DEVELOPMENT REVIEW BOARD  
SUPPLEMENTAL SUBMITTAL

PROJECT NO. PR-2021-005482

**RE: PR-2021-005482: 2121 Yale Boulevard SE  
Design Review Board (DRB) – Supplemental Submittal Package**

**ROADWAY PLAN - GIBSON BOULEVARD**

PEDESTRIAN ISLAND CONNECTION TO EXISTING PAVEMENT  
NOT TO SCALE

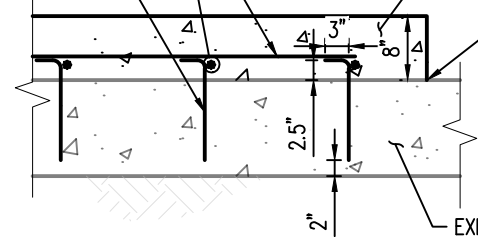
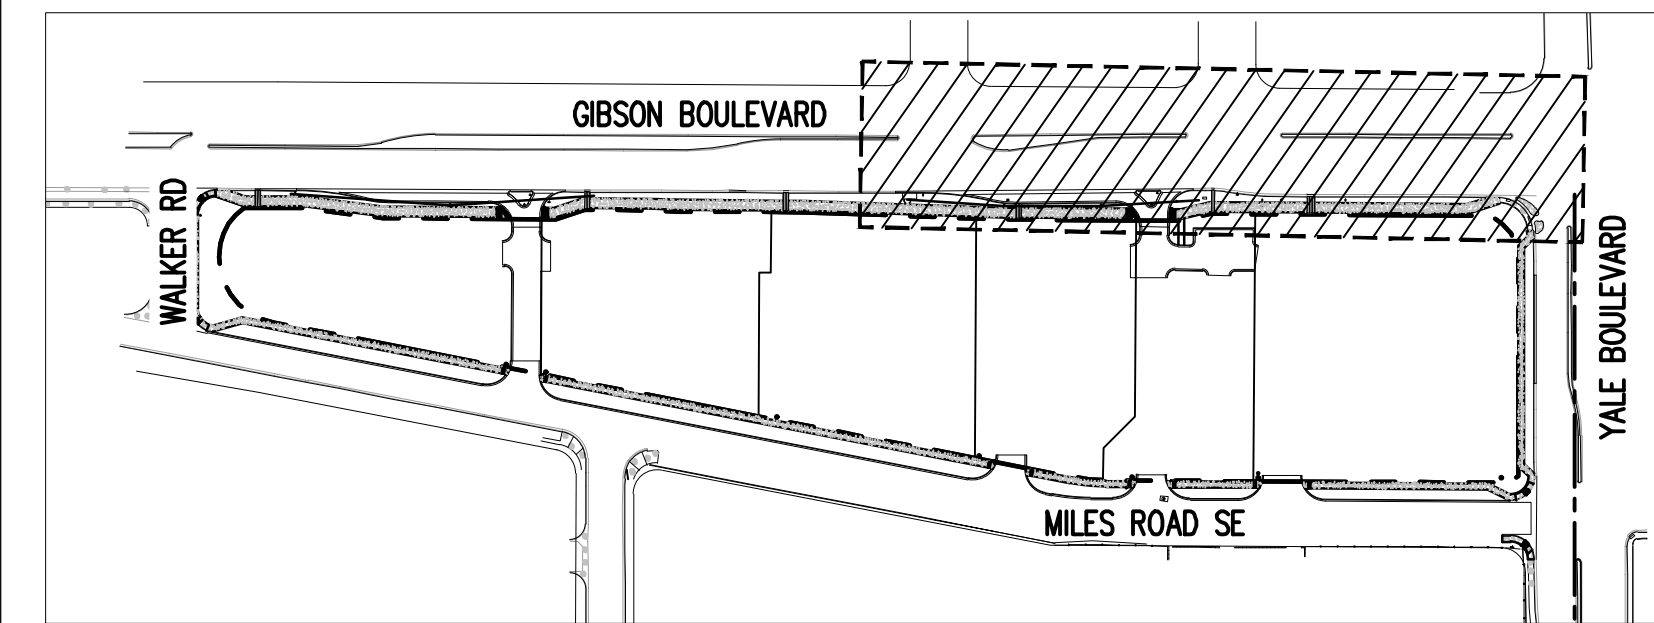
**Galloway Response: Please refer to the enclosed updated Infrastructure List.**
5. Please elaborate or provide an exhibit on the proposed crosswalk island shown on the infrastructure list.

**Galloway Response: Please refer to the enclosed exhibit(s).**

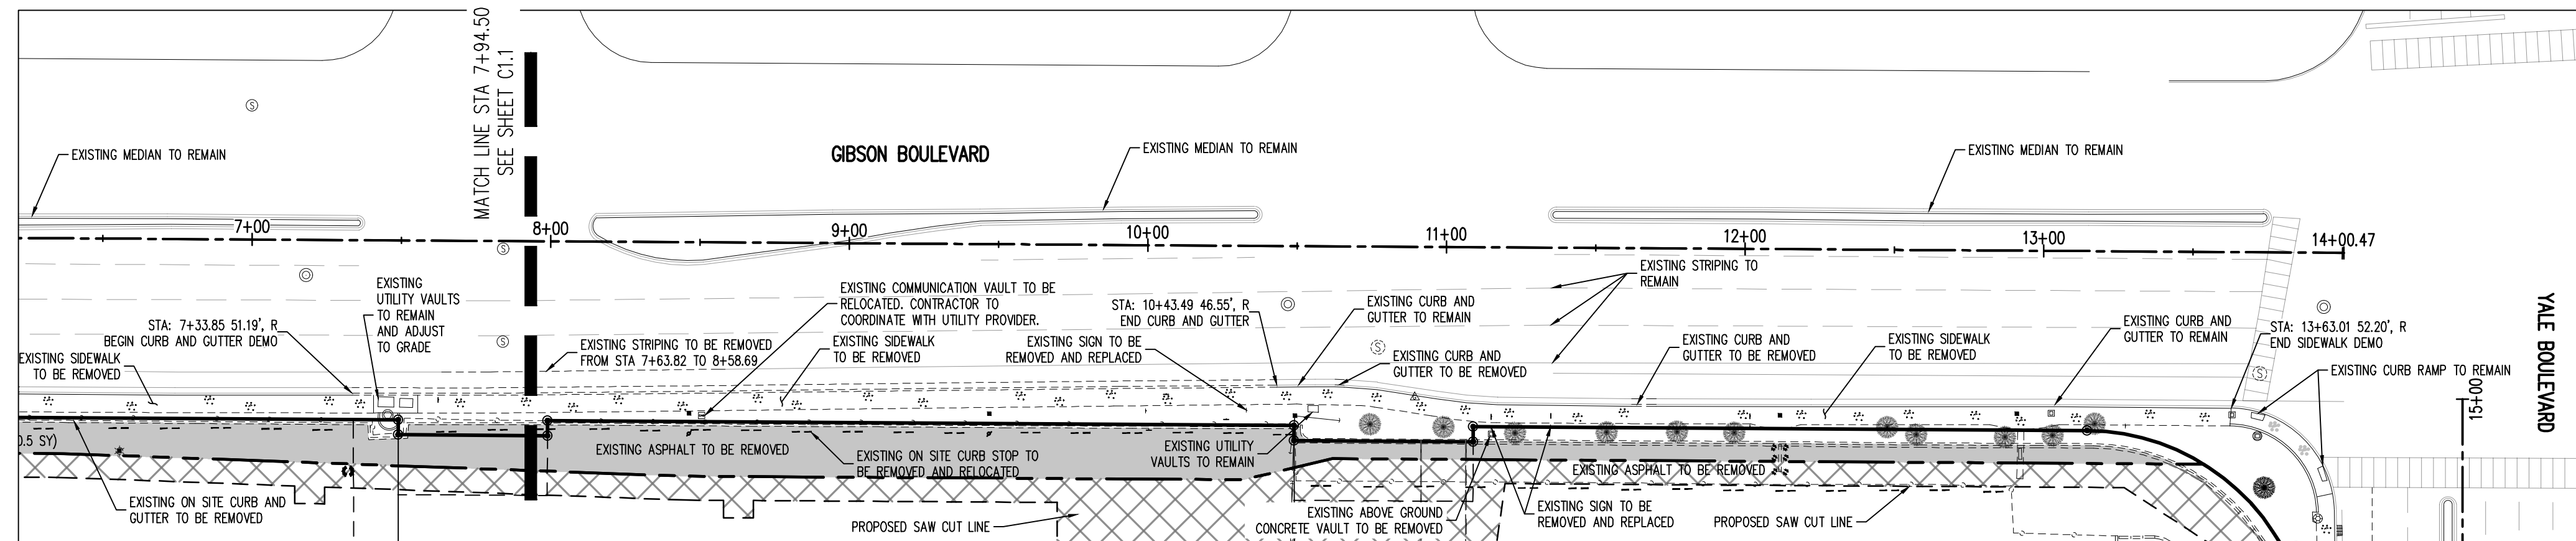
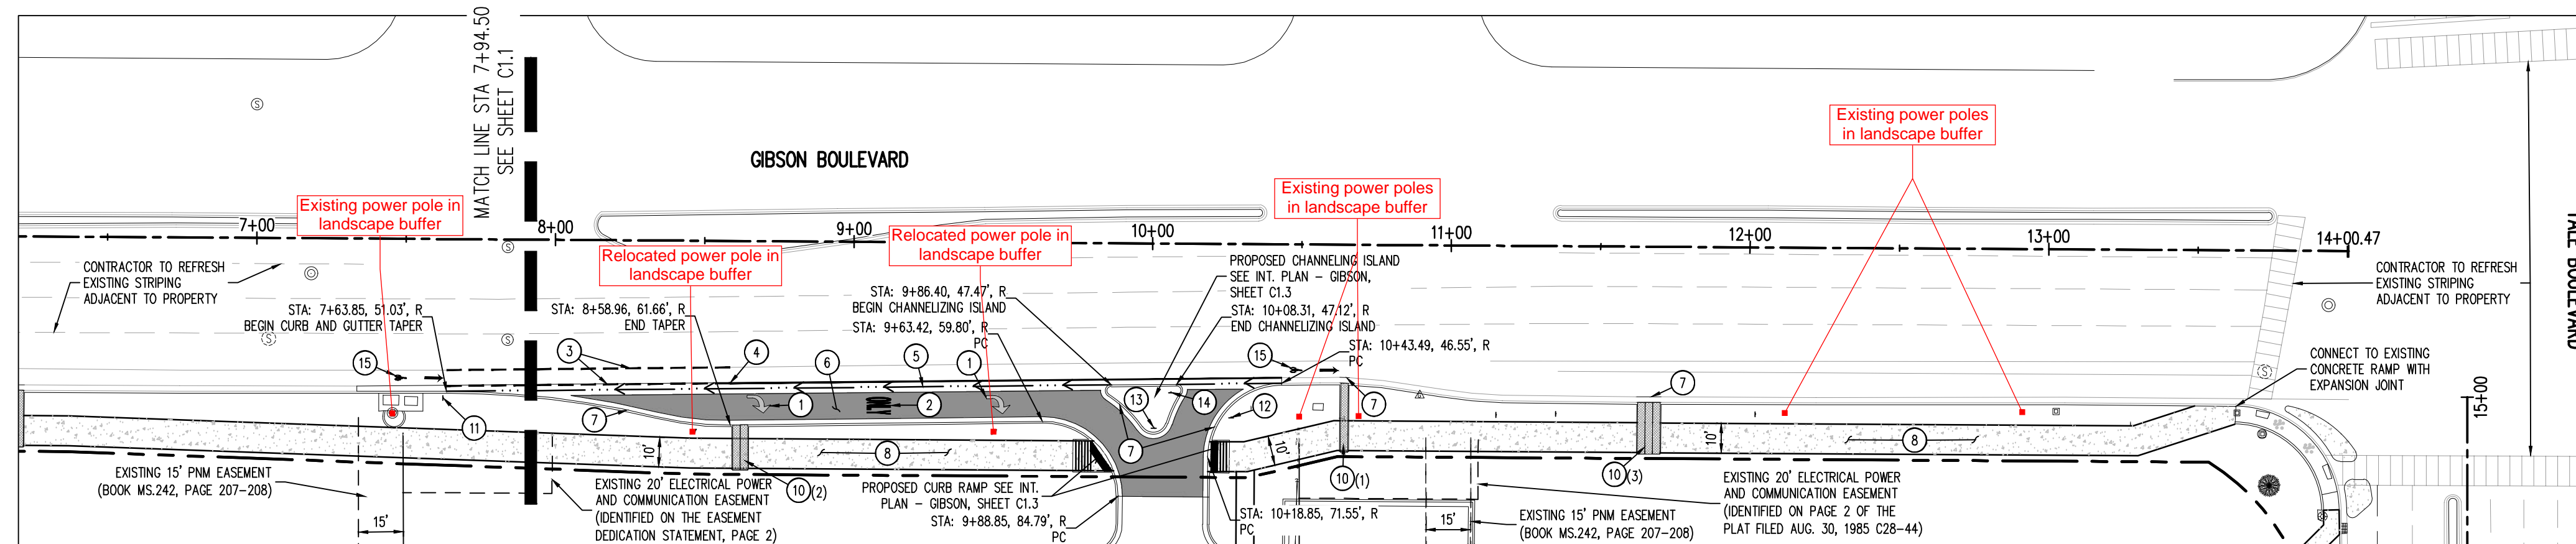
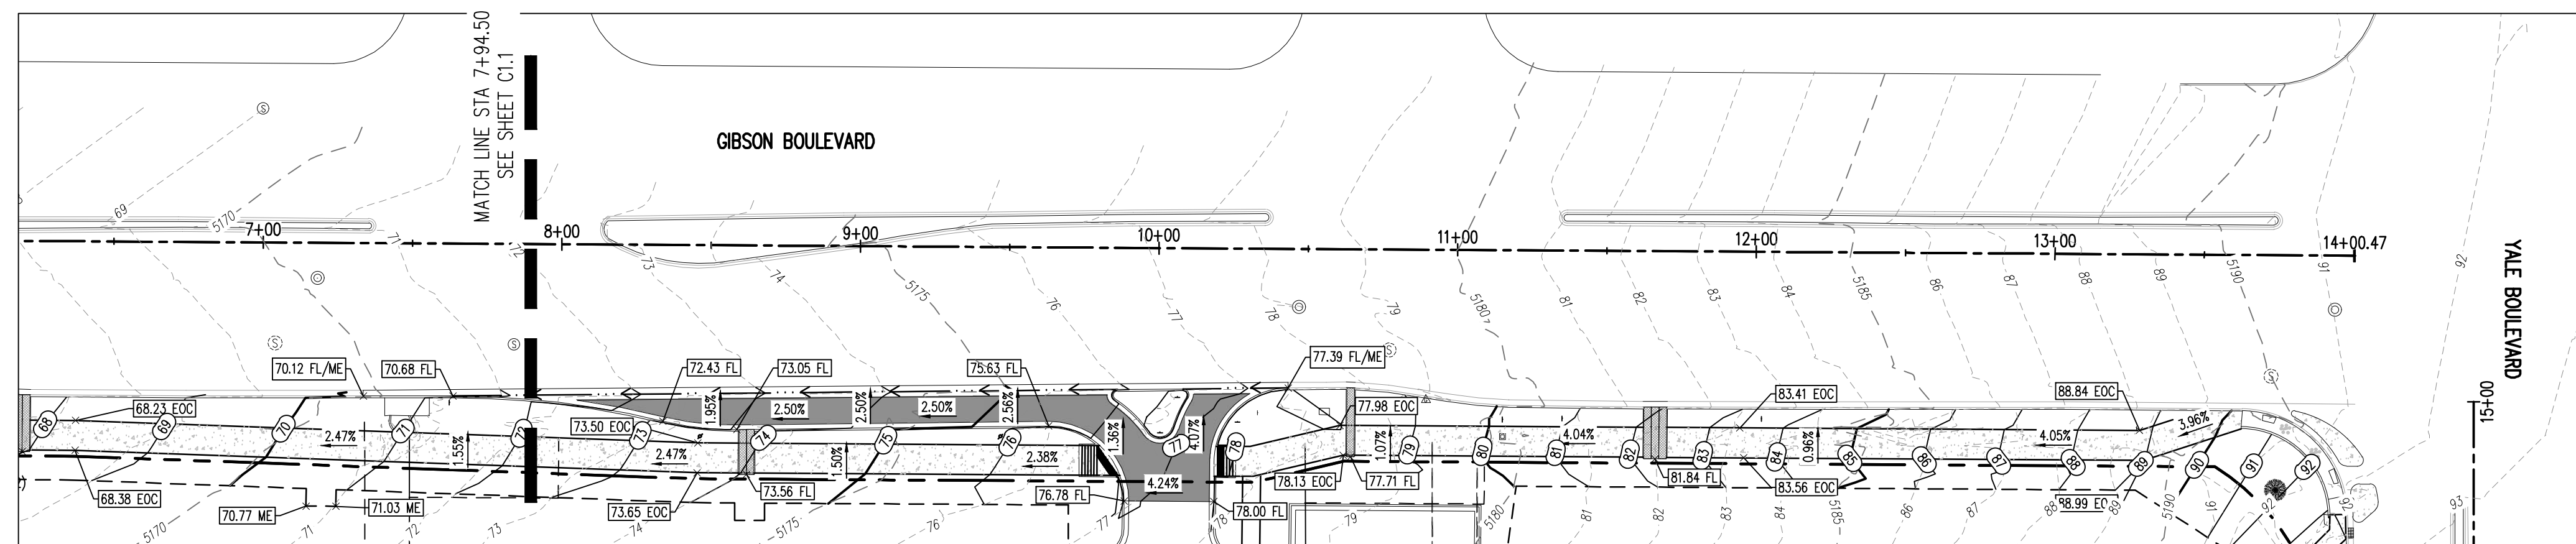
1. The Traffic Impact Study for this development has been approved on March 15, 2022.  
**Galloway Response: Noted, thank you.**
2. Provide cross-sections for all roads surrounding the site along with the application. These shall include the newly proposed lanes, bicycle facilities, and sidewalk.

**Galloway Response: Please refer to the enclosed exhibit(s).**
3. Within application, please explain how the light poles are to be accounted for? (A four-foot pedestrian path is required around all light poles and other obstructions.)

**Galloway Response: Please refer to the enclosed exhibit(s).**
4. For all turn lanes shown on the infrastructure list, provide length of each within item description for further clarification. (This shall match requirements for the proposed Traffic Impact Study.)
